Frequently asked questions:

West Calgary Ring Road North Project

In January 2021, updated plans were published on westringroad.ca and comments and questions were accepted between January 27 and February 14, 2021. A total of 68 submissions were received for the North project.

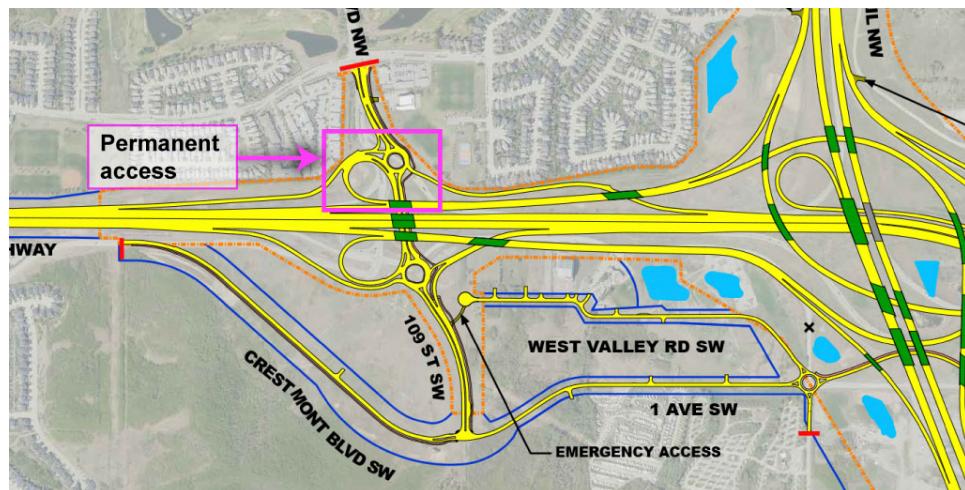
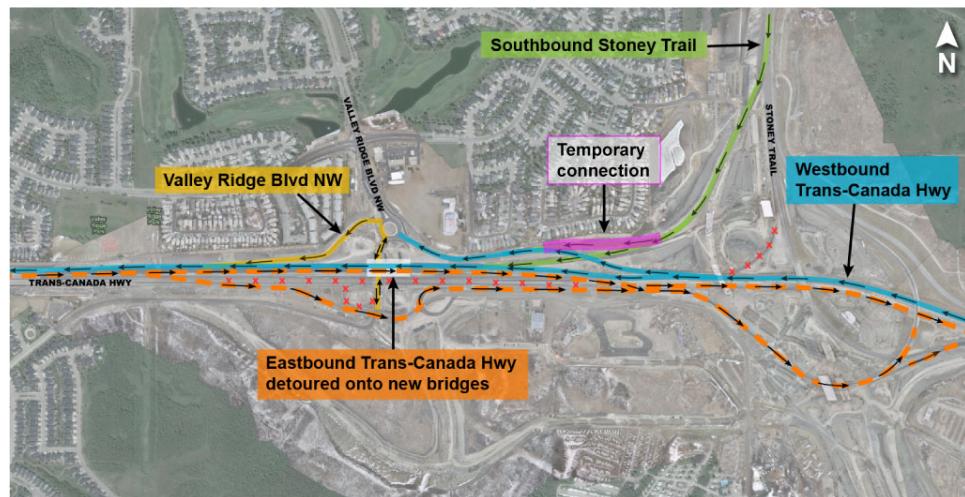
Requests for additional cross sections

Cross sections are intended to provide a general understanding of the road elevation and proximity to homes representative of the design at the time they are created. Areas adjacent to the cross section can be assumed to be similar to what is shown.
